February 07, 2025

**ADDENDUM NO. 3
TO THE
CONTRACT DOCUMENTS
FOR
CUMBERLAND COUNTY TRANSFER STATION**

- AD3-1. Revised Site Civil Drawings
- AD3-2. Revised Bid Form

DESIGNED: J.D.B.	PROJECT NO: CUMBERLAND 22-1
DRAWN: J.R.T.	SCALE: AS SHOWN
APPROVED: S.A.S.	DATE: DEC. 2024
FILENAME: CUMBERLAND-D0263	
SHEET NUMBER: 6	DRAWING NUMBER: S5

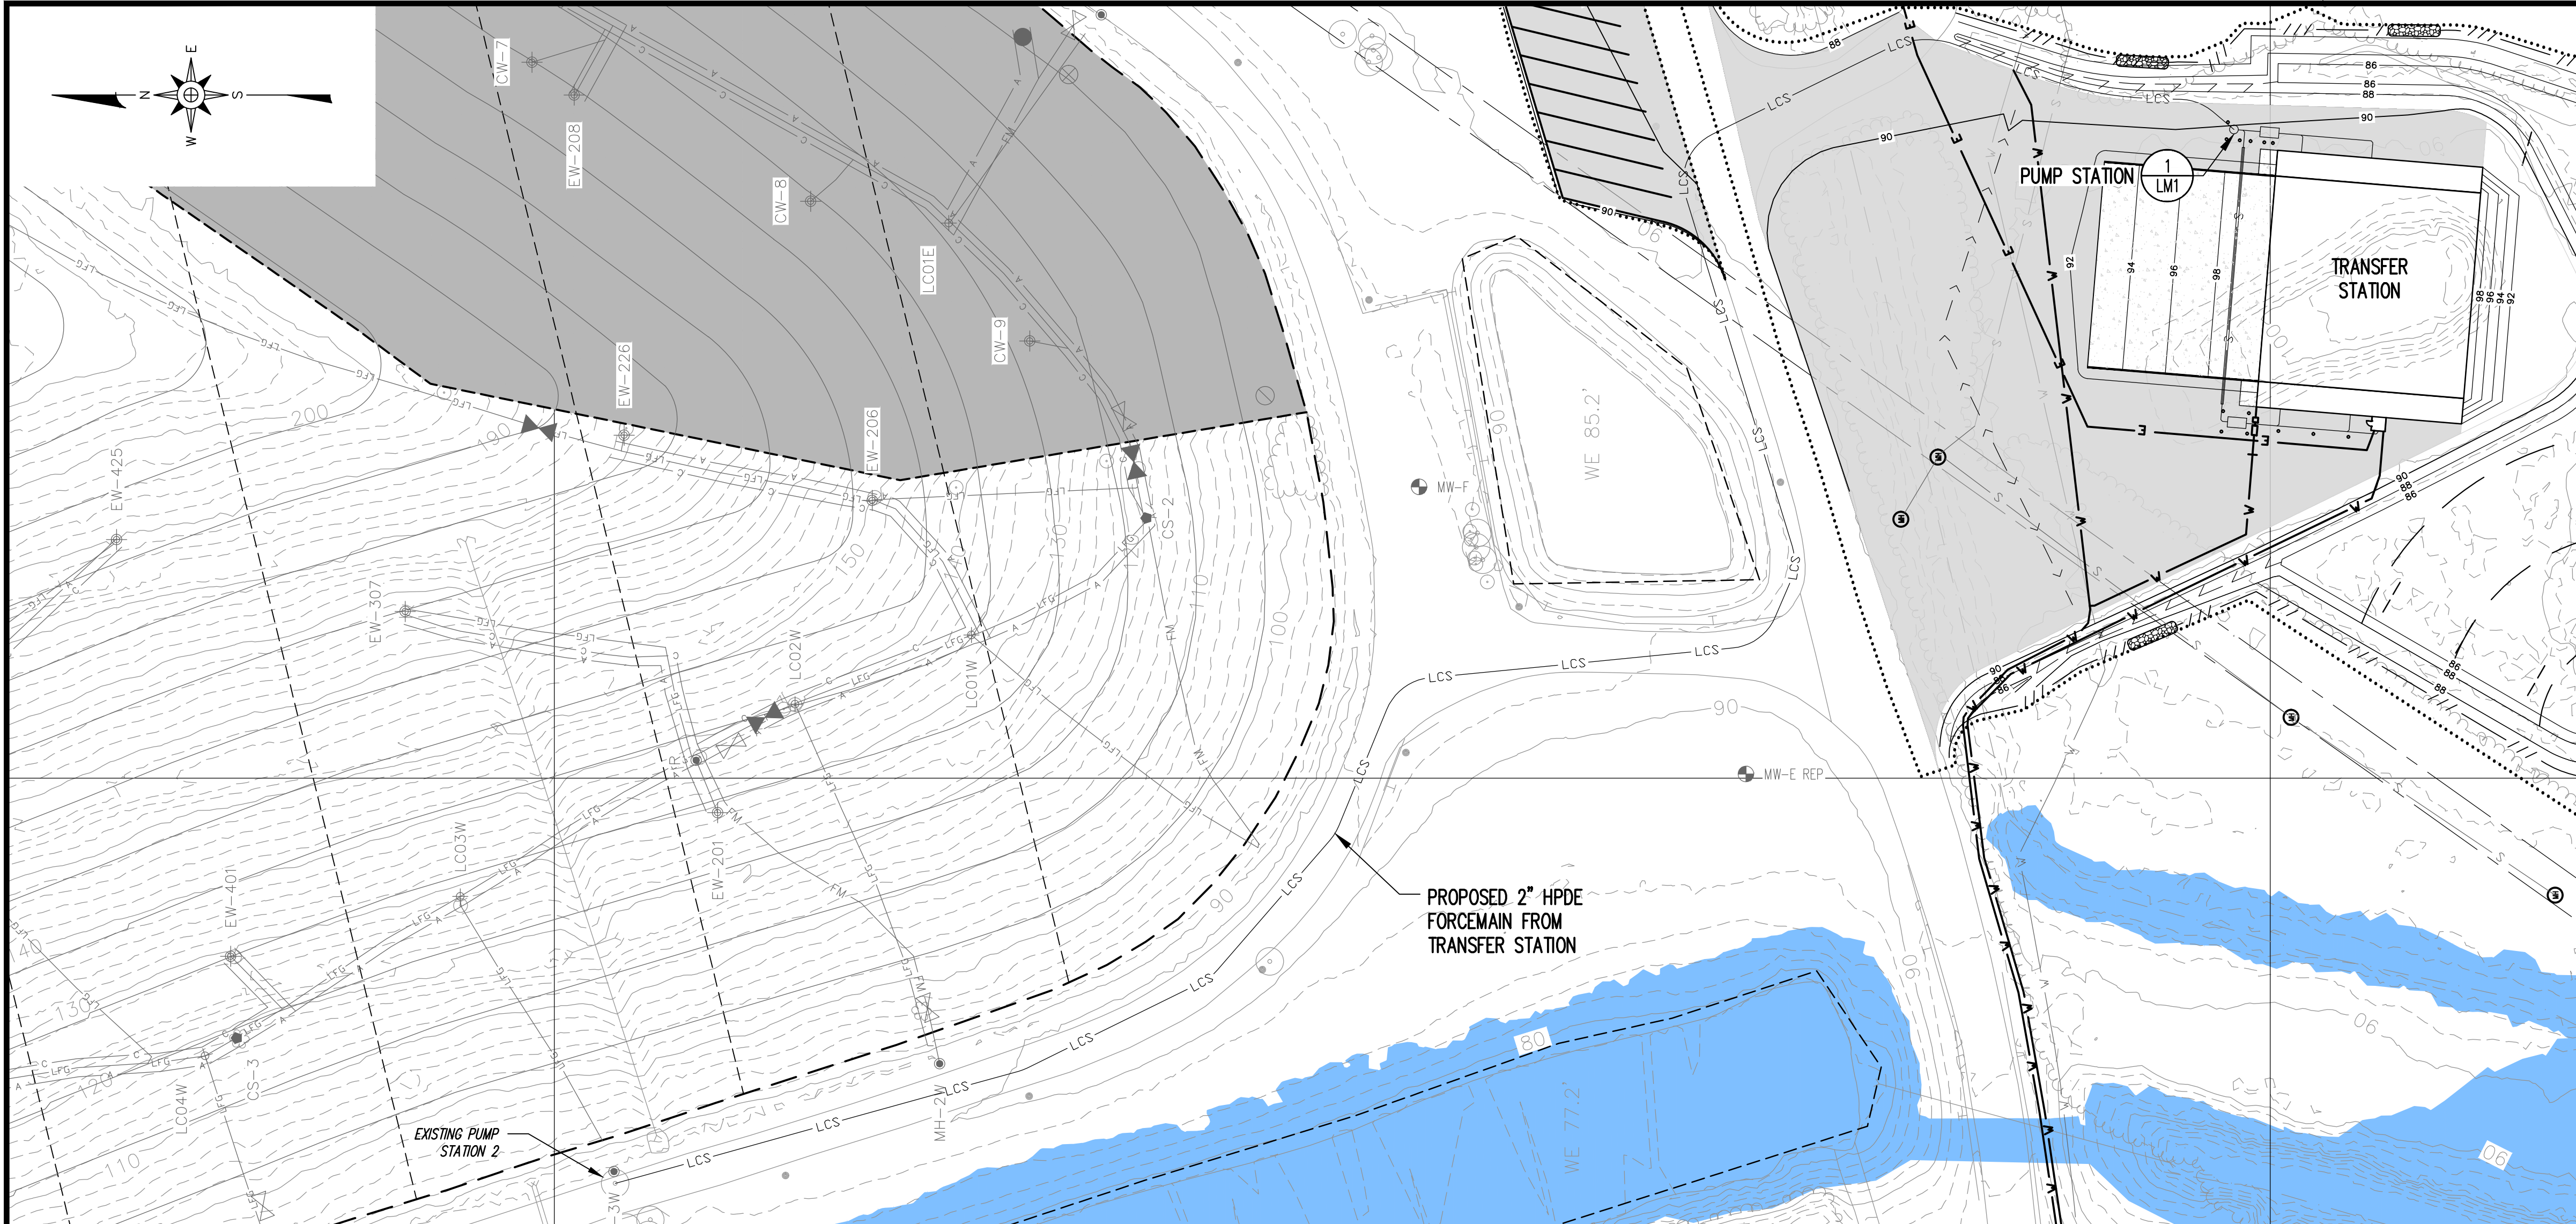
AD3-35. *Please clarify the limits for the proposed aggregate paving. Drawings S3, S4 and S5 do not specifically depict limits of aggregate paving. The gray shaded areas appear to represent Flood Zone AE.*

See revised Drawings.
